2 REVISIONS TO THE DRAFT EIR

2.1 PROJECT MODIFICATIONS

2.2 REVISIONS TO THE DRAFT EIR

Exhibit F2-1

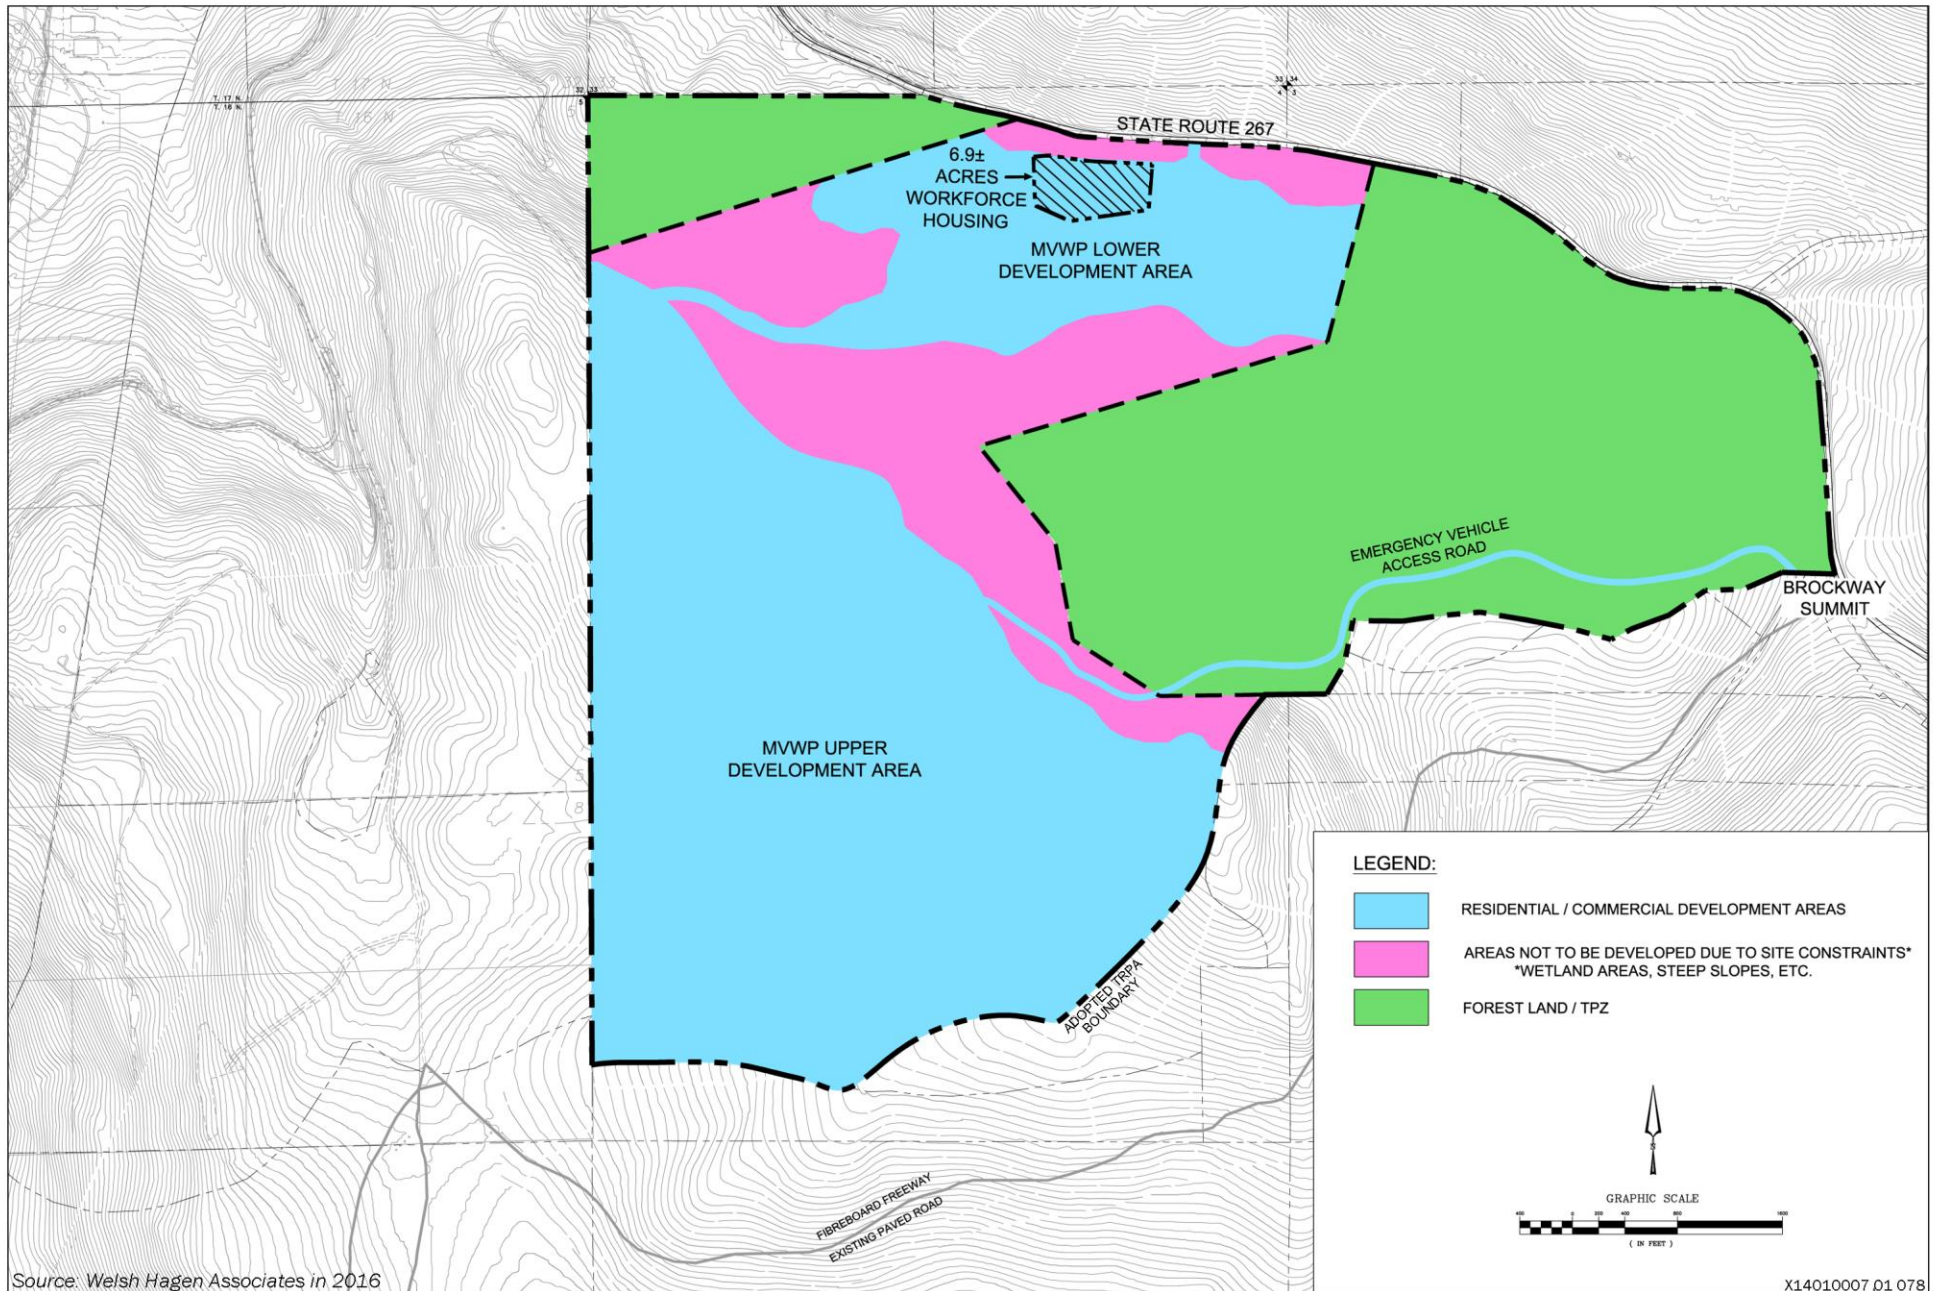
The MVWPSP has been revised to provide for workforce housing on the project site rather than payment of an in-lieu fee. Consistent with Placer County General Plan Policy C-2, a dedication of land to Placer County within the MVWP site is proposed. The proposed employee housing site is located within the developable portion of the plan area, adjacent to the proposed transit shelter (see Exhibit F2-1 on the following page). This dedication of land is intended to provide workforce housing at important milestones as well as to allow Placer County to adapt to regional needs over the course of time. The dedication of land would meet the requirements of Policy C-2.

The dedicated lands would be restricted to workforce housing development. The employee housing site could contain up to 21 units. Those units would be subtracted from the total proposed unit count of 760 for the proposed development; therefore, the total number of units allowed within the project site would not exceed 760. As discussed briefly below, the impacts of the proposed housing land dedication have been fully analyzed in this Draft EIR (because the total unit count and disturbed acreage would not change), and the conclusions of the EIR have not changed.

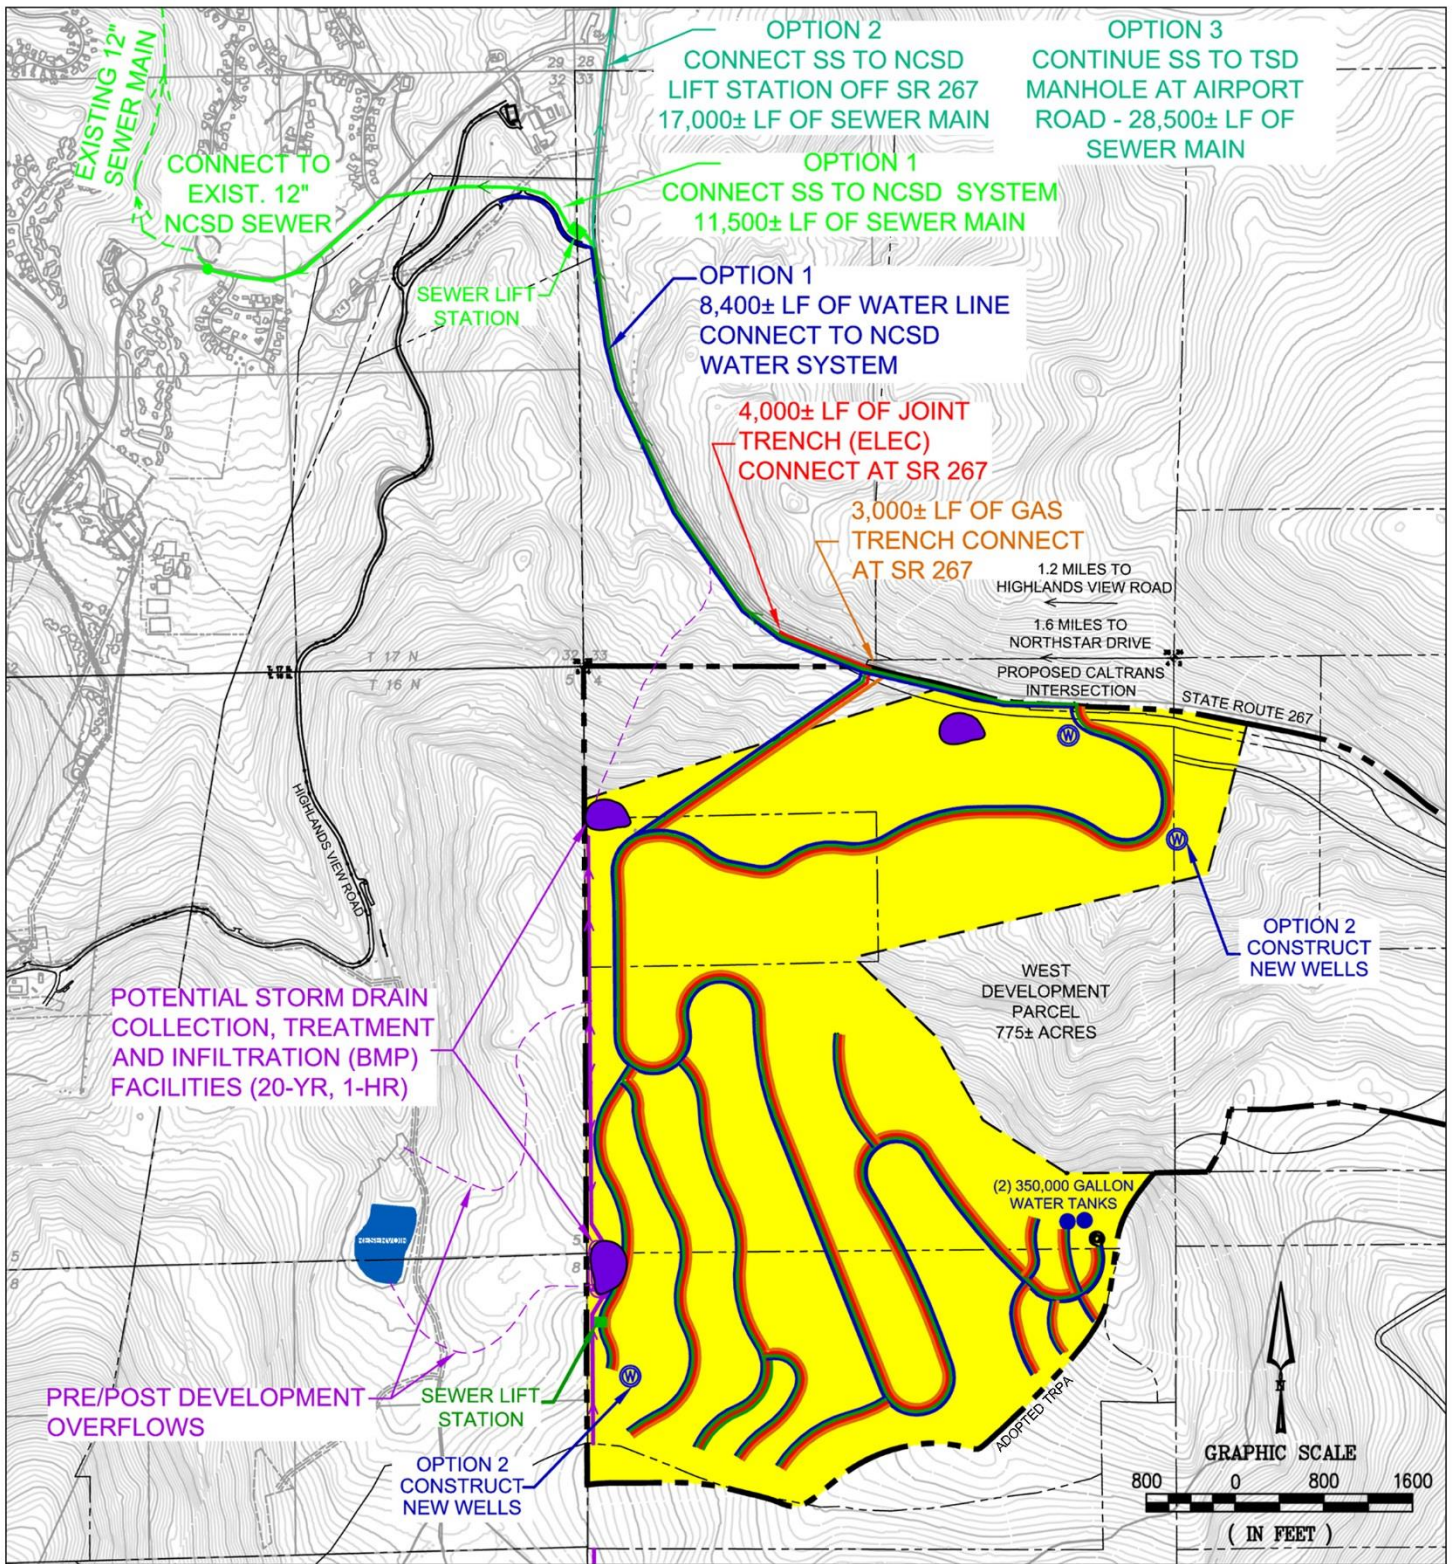
Per responses to comments LA7-2 and LA7-3, Exhibit 3-12 and Exhibit 16-2, MVWPSP – Proposed Utility Connections, have been revised to display the sewer lines located within the MVWPSP proposed project streets and to show the location of the proposed sewer lift station. Please see the revised exhibits on the following page.

Per response to comment LA7-19, LA7-20, LA-22, Exhibit 16-2, MVWPSP – Proposed Utility Connections, on page 16-19 has been revised as shown on Revised Exhibit 16-2 (see Revised Exhibit 3-12).

Revised Exhibit 9-14

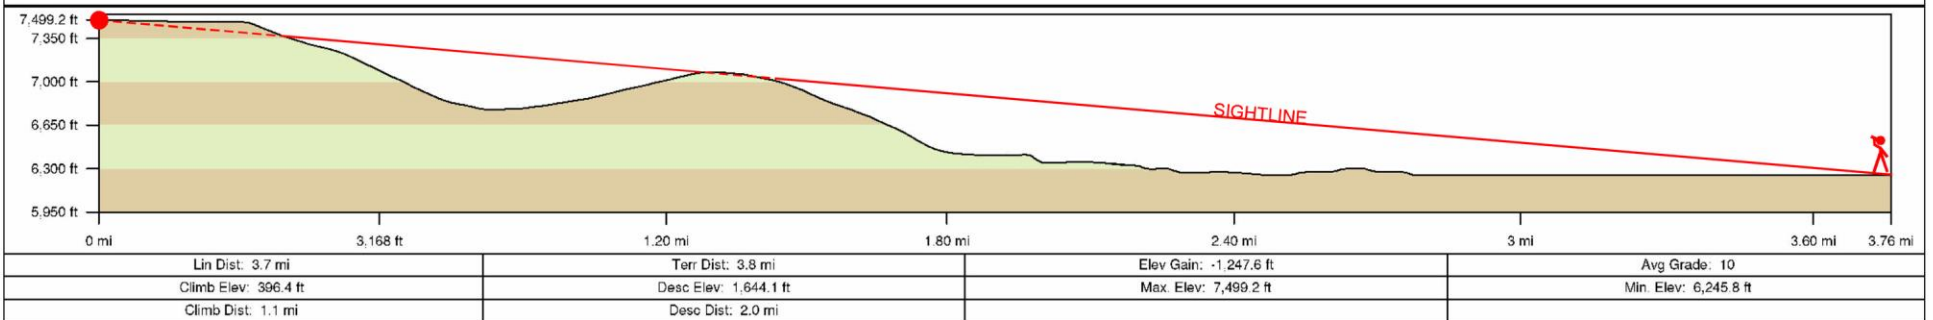
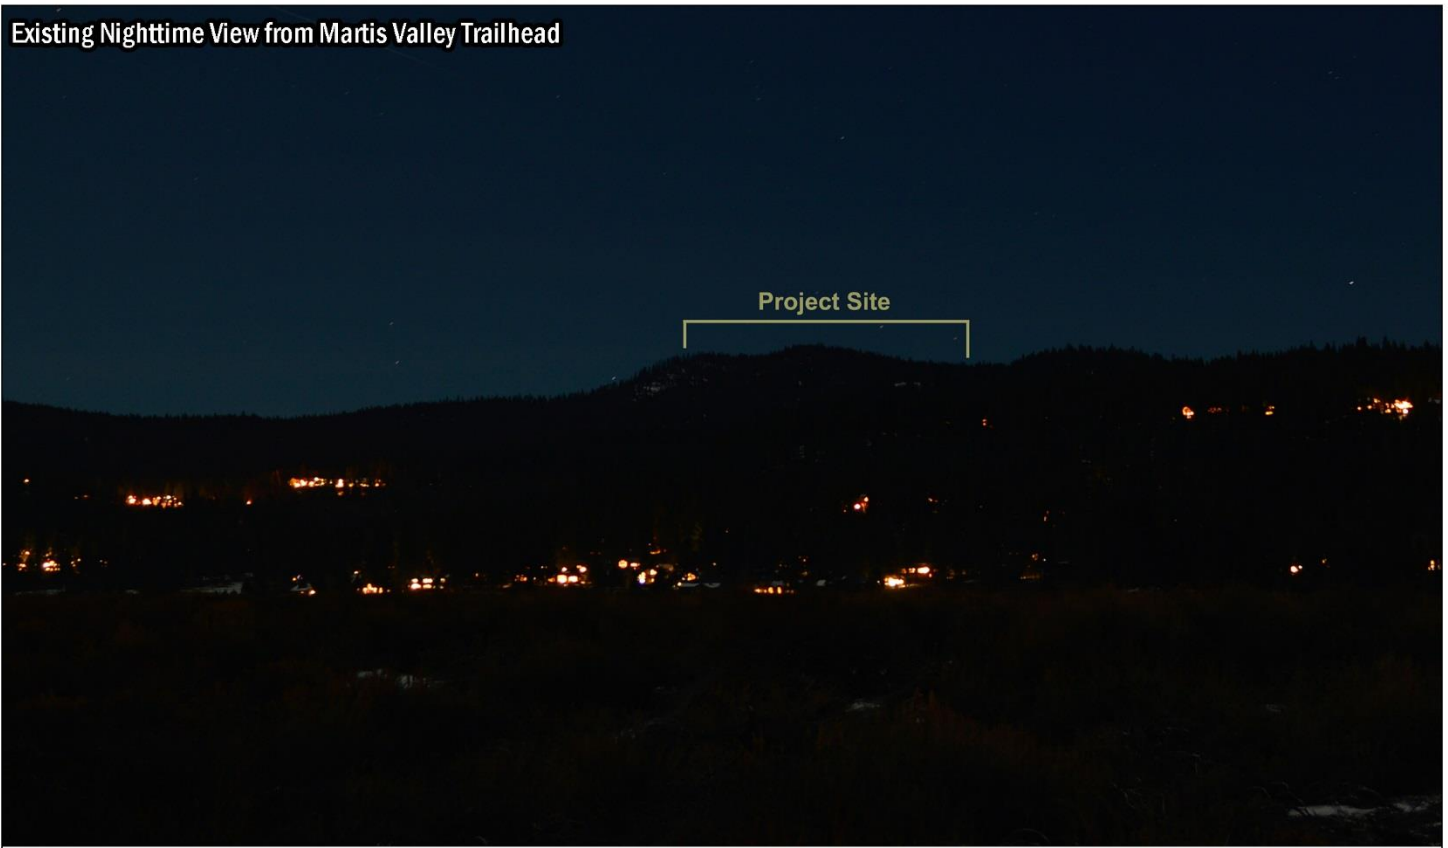
Per response to comment IO18-52, Exhibit 9-14 has been corrected, as shown on the following page.

Revised Exhibit 9-34

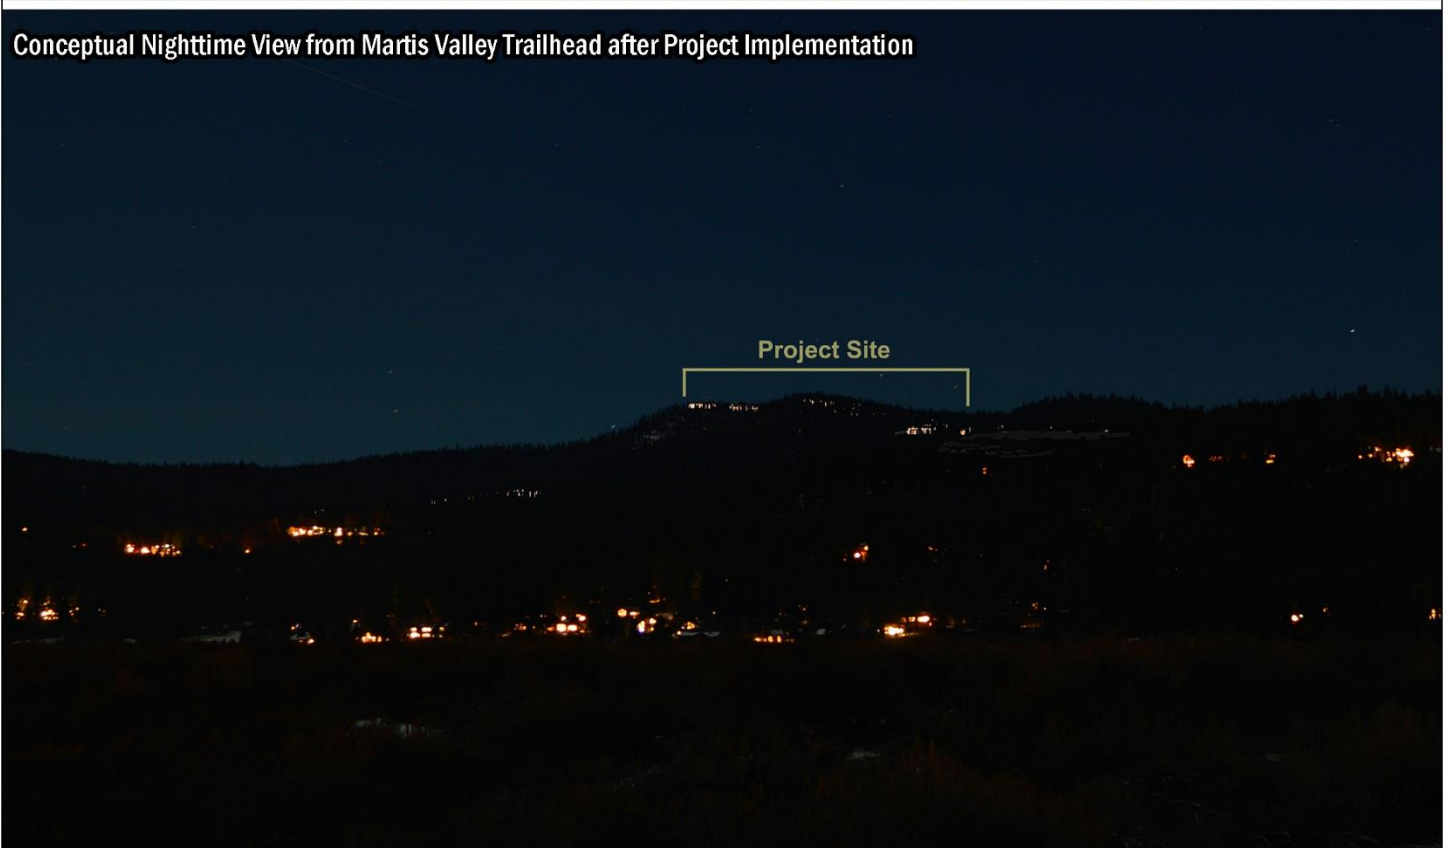
Per response to comment IO41-26, Exhibit 9-34 of the Draft EIR is revised, as shown on the following page.

Per response to comment IO41-26, the following bullet is added at the end of the bullets on page 9-54 of the Draft EIR, and the text on page 9-54 is revised to read as follows:

- ▲ Timers, motion-sensors, or equivalent devices on both residential and commercial buildings, shall be implemented on exterior lighting fixtures at night near buildings, where applicable, to avoid continual lighting of surfaces.
- ▲ Yellow spectrum light sources, such as low-pressure sodium lamps and narrow-spectrum amber LEDs, shall be used for the majority of outdoor lighting. Other spectrum lighting may be used where necessary for a particular purpose, such as safety.
